Town of Hilton Head Island  
**Design Review Board Meeting**  
Tuesday, June 8, 2021 – 1:15 p.m.  
**REVISED AGENDA**

i. Tidal Wave Auto Spa, DRB-001157-2021

ii. Benny Hudson Seafood, DRB-001319-2021

The following is a response to your comments received May 11<sup>th</sup>, 2021 for the Pre-Development Plans dated May 10<sup>th</sup>, 2021.

**PRELIMINARY SITE PLAN**  
**TIDAL WAVE AUTO SPA**  
 1 PLAZA DRIVE, HILTON HEAD ISLAND, SC 29926  
 HILTON HEAD ISLAND, BEAUFORT COUNTY, SOUTH CAROLINA  
 Prepared for:  
**SHJ CONSTRUCTION GROUP**

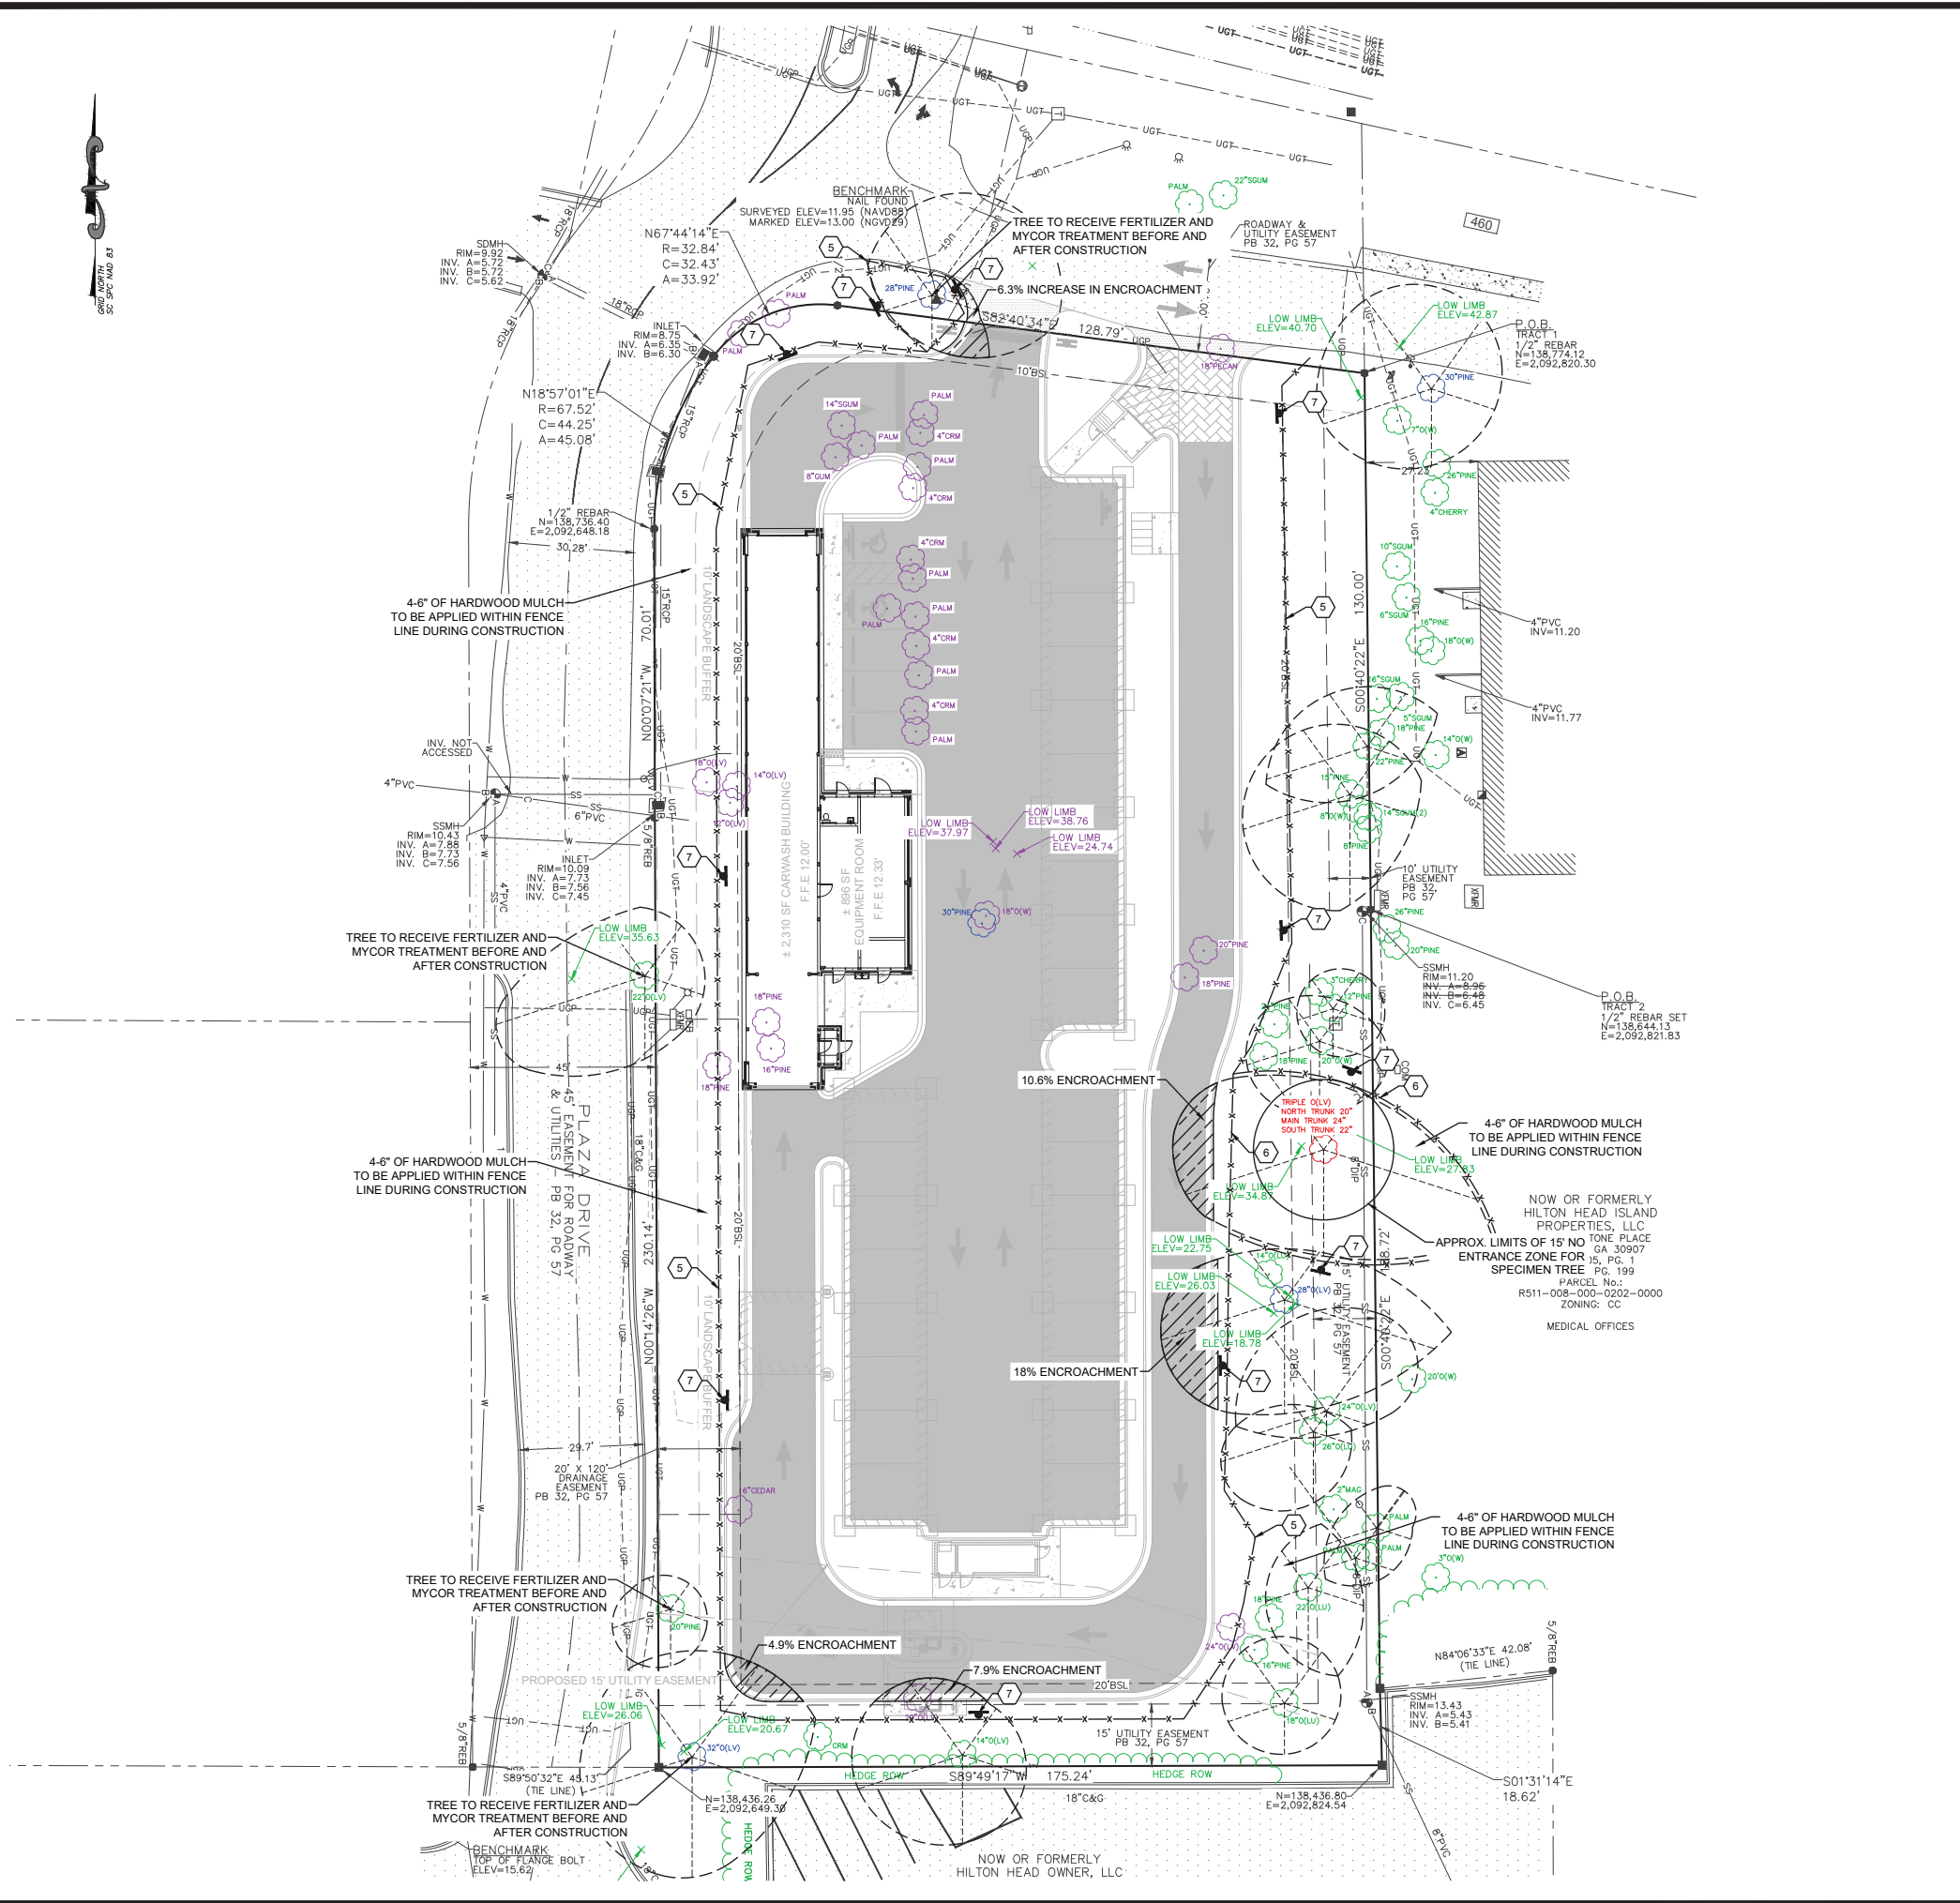
1. This project requires a DPR.  
EMC Engineering is aware that the project requires a DPR. The process will be started to gain DPR approval.
2. **Sheet C4.0:** 12' landscape island is required between parking bay and drive aisle.  
The drive aisle was shifted to the East at the north of the site in order to create a 12' landscape island. Towards the south of the site, the landscape island was reduced to preserve the existing significant and specimen trees in that location in accordance with section 16-5-107 G. e.

5. **Sheet C4.0:** Remove the existing, unused curb cuts on Plaza Drive and replace the curb to match existing.  
Both of the curb cuts on Plaza Drive are now shown to be demoed and replaced in a way to match existing drainage and road conditions.

**PRELIMINARY TREE PROTECTION PLAN**

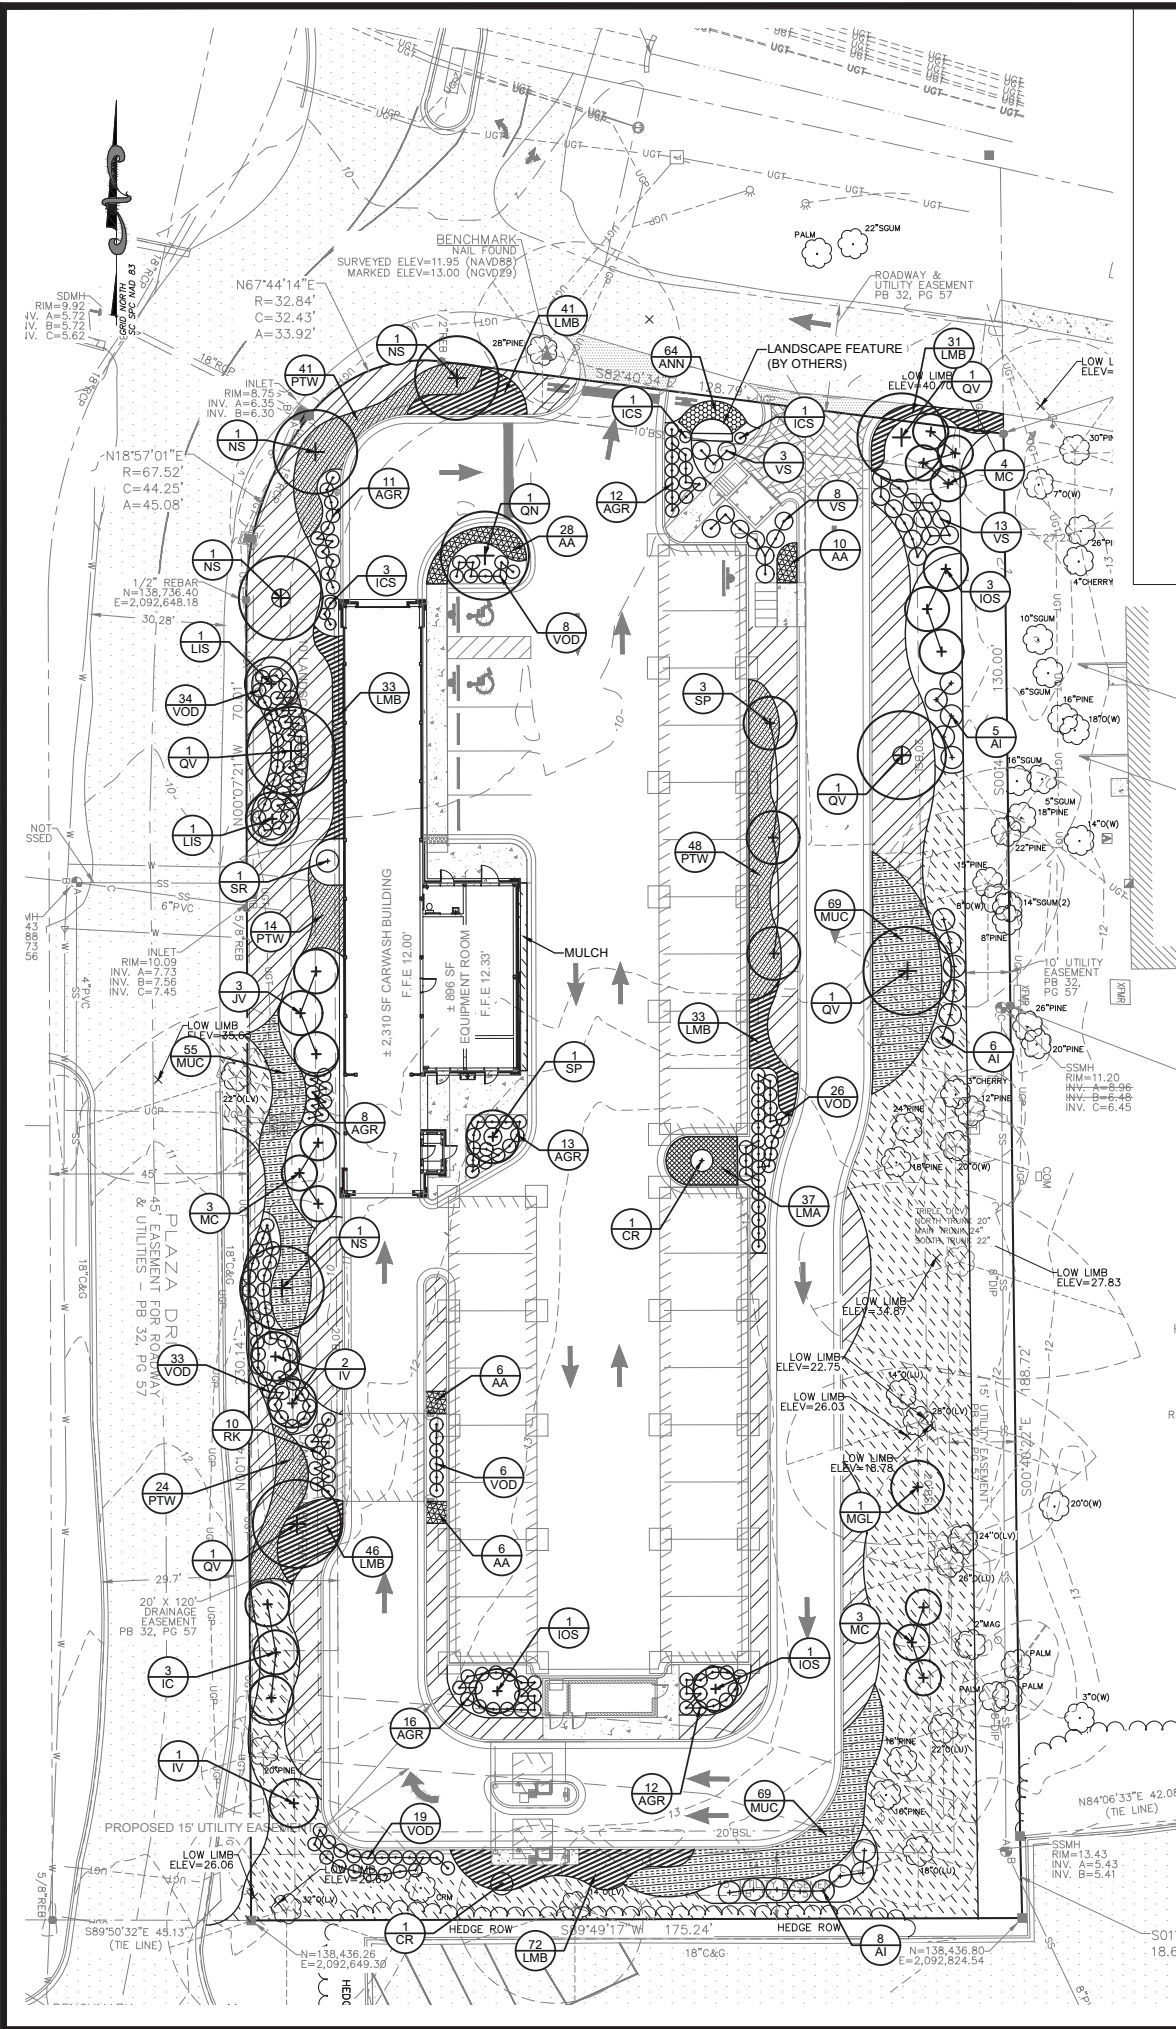
1. **Sheet C4.1:** Specify on the Tree Protection Plan the location of tree protection fence and specify 4-6" hardwood mulch within the fence during construction.

2. **Sheet C4.1:** Specify pre and post construction fertilization and mycor treatment of the 28" pine, 22" oak and 32" oak along Plaza Drive.  
Fertilization and Mycor Treatment are specified on the plans for all (4) of the large existing trees along Plaza Drive.

Rough locations for the tree protection fencing are shown on the tree protection plan. Warning signage is shown at least every 150' and mulch is specified within tree protection zones. A final tree protection plan will be provided that meets all of the city's requirements.
